Norfolk Gliding Club Ltd

Norwich to Tilbury EN020027

Written Representation

Summary

Figure 3: Proximity of existing (blue) / proposed (red) power line infrastructure to Tibenham aerodrome. Nearby Priors Farm aerodrome indicated by white pin.

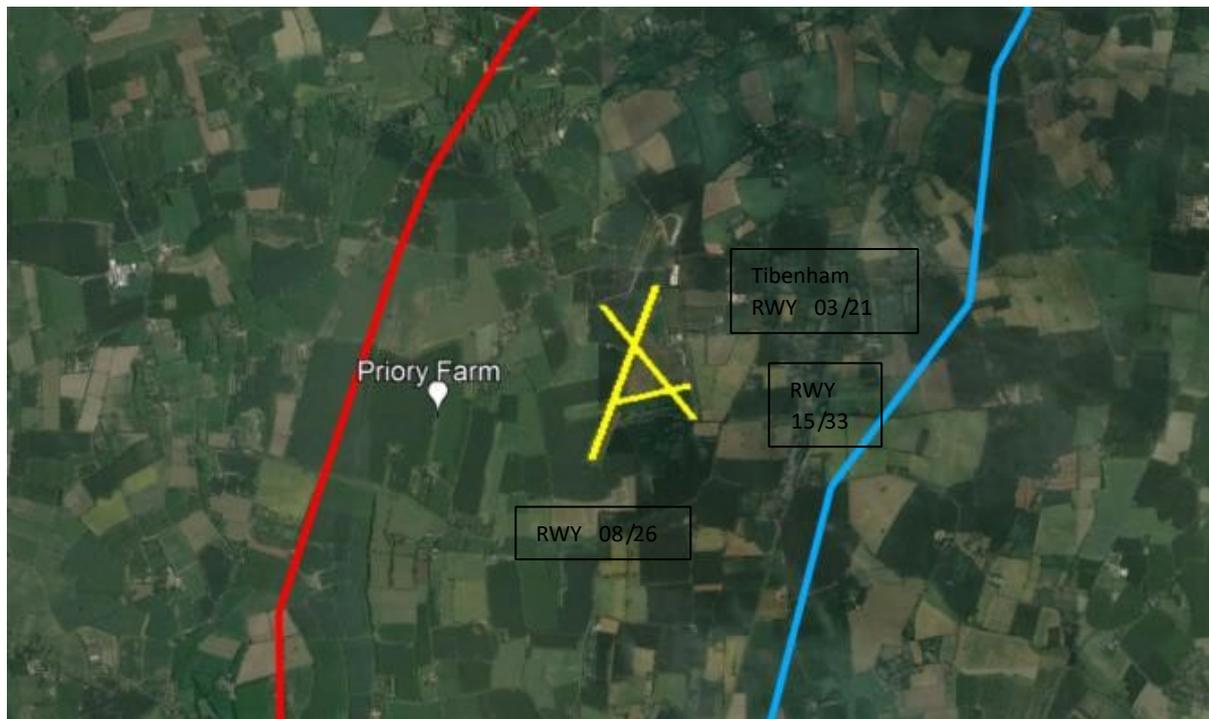
Proximity to proposal: 2.4km from RWY 08 threshold on 08/26 extended centreline (W); 2km from the RWY 15 threshold on 15/33 extended centreline (NW)

Tibenham aerodrome facilitates both winch and aerotow glider launch and is located approximately 2km from the proposed power line (red) at its closest point. As shown in Figure 3, the proposed power line would create a north to south corridor around Tibenham, effectively sandwiching the aerodrome between the existing power line infrastructure (blue) to the east at a range of 1.3km at its closest point. Also note the proximity and position of Priors Farm aerodrome (located at just over 1km from the 08 threshold Tibenham), compounding effects from any impact on Priors Farm should be considered when assessing Tibenham.

Figure 4a: Priory Farm aerodrome's larger circuit shown in green, the smaller in turquoise. Tracks for departing aircraft in dark blue from each runway end. Proposed power line infrastructure in red; existing in light blue. All circuit/departure

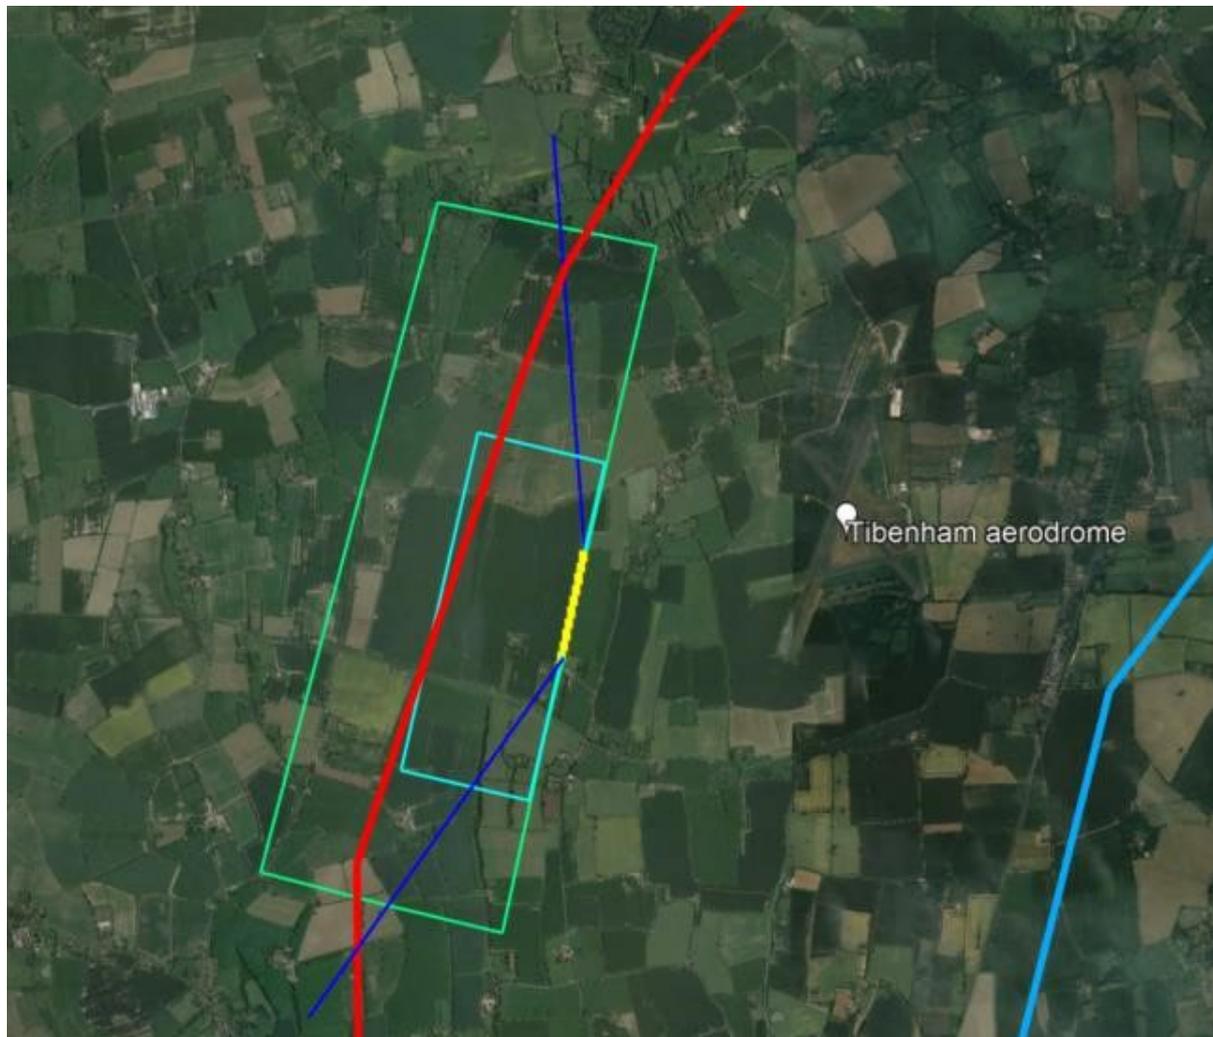
As shown in Figure 4a the proposed infrastructure would require aircraft to cross the power line at low level at multiple points in the circuit, and on the published departure tracks also. The proposed scheme represents a new hazard for aircraft experiencing an emergency in the vicinity of the aerodrome. The new vertical obstruction created by the power line may preclude stricken aircraft from recovering to the runway, forcing pilots to consider off-aerodrome landing solutions.

Figure 1: Proposed pylon route relative to Tibenham Airfield

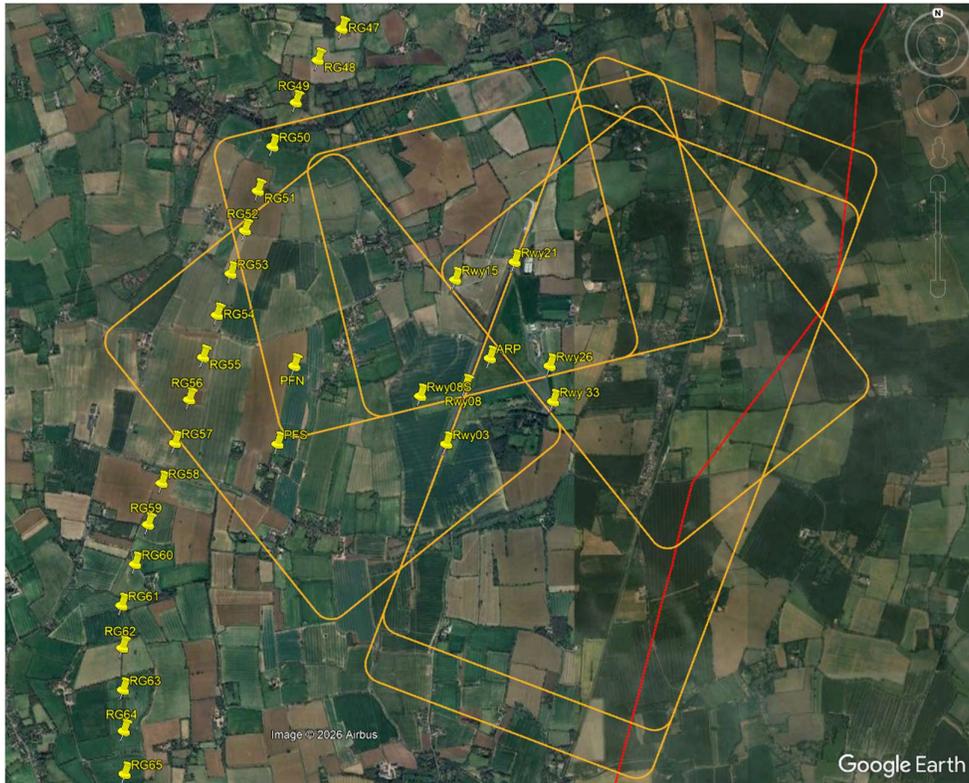
3.6.1 A conflict with circuit flying is immediately apparent from Figure 1 which shows that two of the circuits (Runway 08 and Runway 15) cross the pylon route whilst a third circuit (Runway 26) passes within about 320 m of the pylon route. Given the 500 ft rule requirement and the absence of any significant obstacles in the area at present, the pylon route would increase the minimum height of circuits from 500 ft by nearly 200 ft. It would therefore place a new restriction on operations, in particular bad weather circuit flying at 500 ft, and lead to a loss of amenity. However, to avoid conflict with the Priory Farm Airstrip, those circuits are normally not flown such that this concern will not apply in practice. The primary concern in respect of circuit flying is that the pylon route would preclude Priory Farm Airstrip operations to the west, forcing them to the east where they would conflict with other Tibenham operations.

Glide slope – pictorial, not to scale

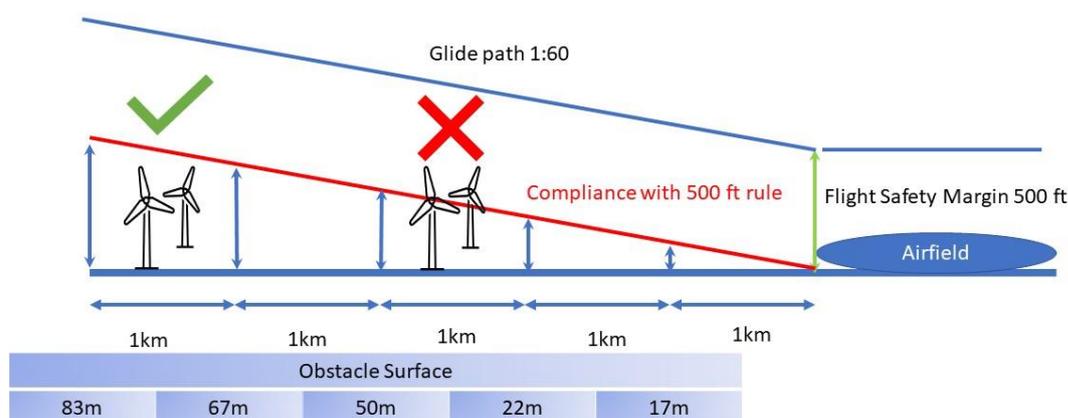
In order to comply with these rules pylons of the plan height would need to be at least 3 km from the airfield boundary (see picture). Whilst an exemption exists for landing and taking off, at 3km out a glider is not yet in the landing phase of their flight, and a pilot will be concentrating on the remaining flight back to the airfield.

Figure 4a: PRIORITY FARM aerodrome’s larger circuit shown in green, the smaller in turquoise. Tracks for departing aircraft in dark blue from each runway end. Proposed power line infrastructure in red; existing in light blue. All circuit/departure illustrations are approximate.

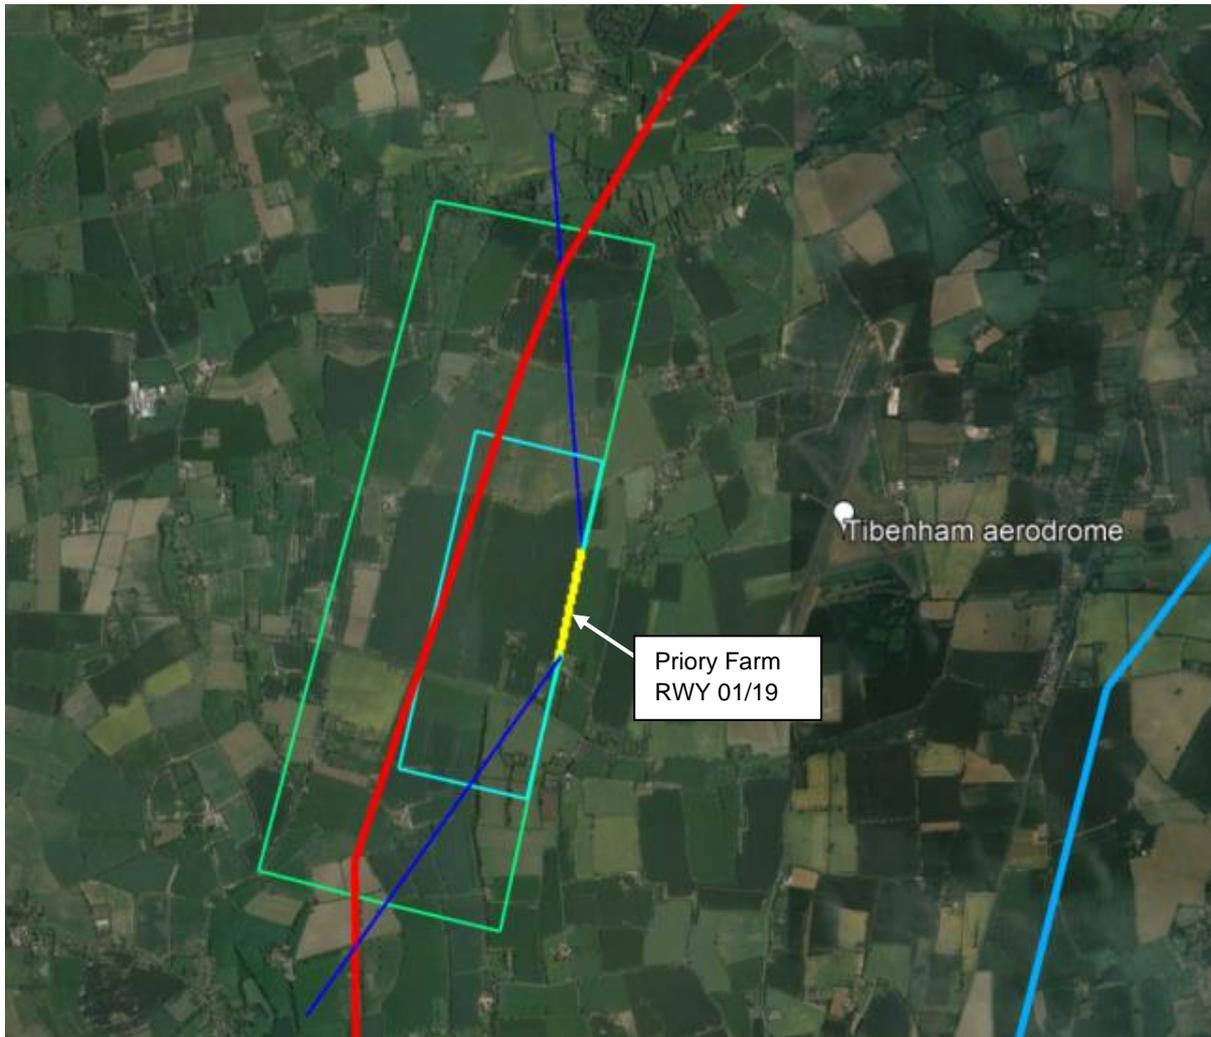
As shown in Figure 4a the proposed infrastructure would require aircraft to cross the power line at low level at multiple points in the circuit, and on the published departure tracks also. The proposed scheme represents a new hazard for aircraft experiencing an emergency in the vicinity of the aerodrome. The new vertical obstruction created by the power line may preclude stricken aircraft from recovering to the runway, forcing pilots to consider off-aerodrome landing solutions.

Figure A9.1: Code 1 Runway Inner Horizontal and Conical Surfaces and Defined Circuits for Tibenham Runways

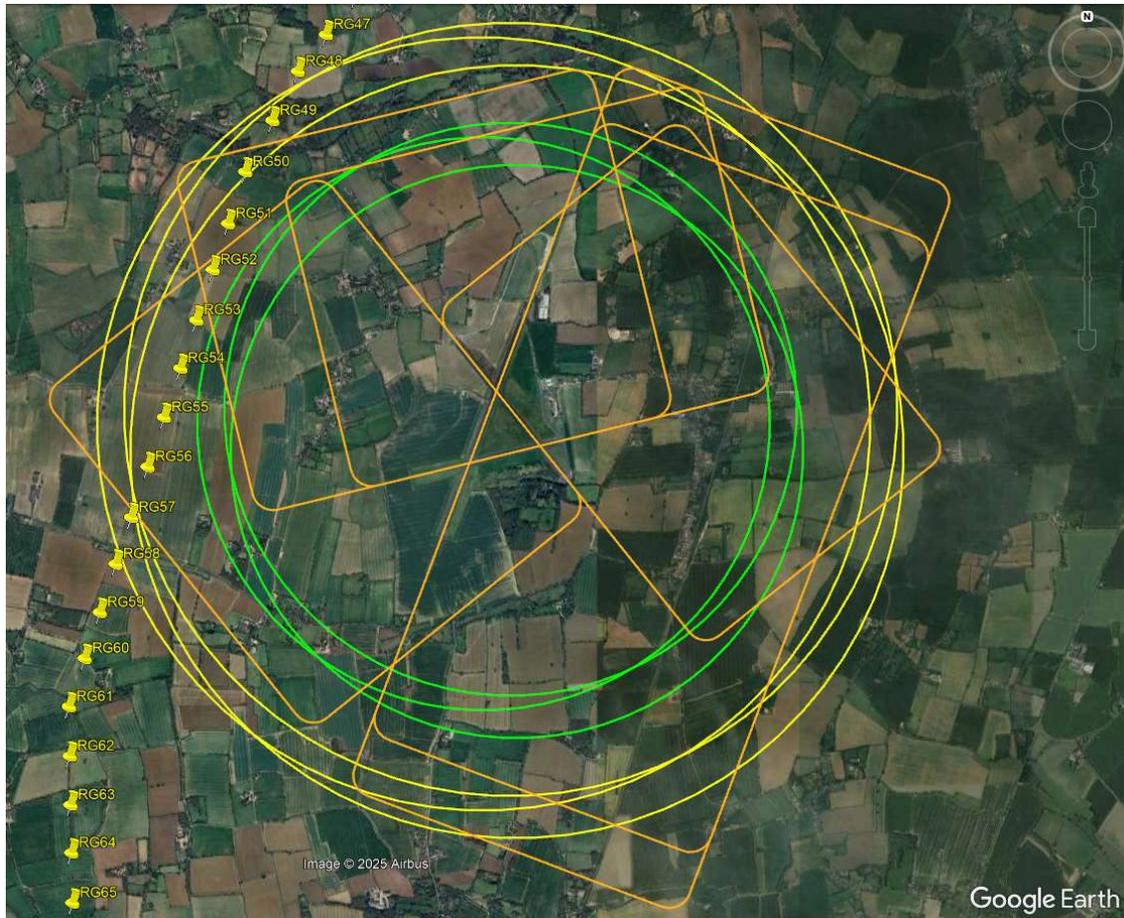
The basic OLS were established immediately after the Second World War, primarily with reference to operational experience up to that time. As noted earlier, the inner horizontal and conical surfaces were intended to provide for visual circling manoeuvring prior to landing, based on the rather simplistic notion of circling centred on a single runway. In practice, aircraft do not simply circle about the runway centres but fly defined circuits at airfields. The circuits defined for operations at Tibenham extend slightly beyond the limits of the OLS in some areas, as shown in Figure A9.1.
